MXRC2

Update from MXRC1

Modification

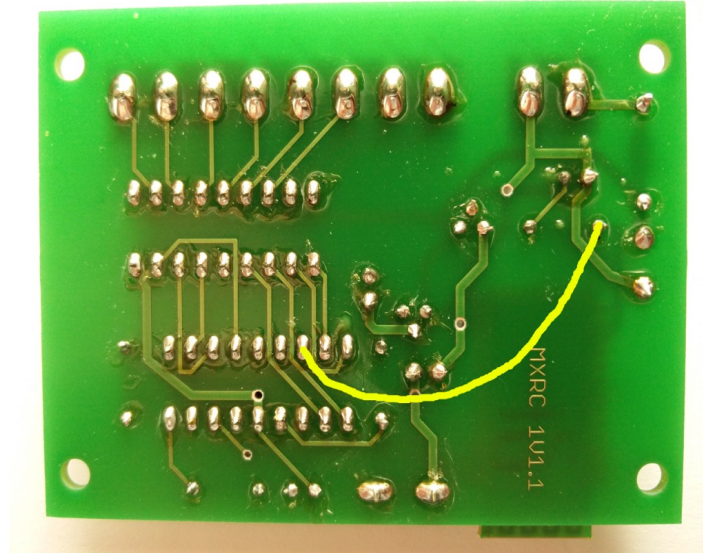
- Replace the PIC chip (new PIC16F1827)
- make pc board modification as above
(connect pin 16 of the PIC chip to pin 24 of the HC-06 where the resistor for the red LED is connected)
- press the button and switch the power on for factory settings
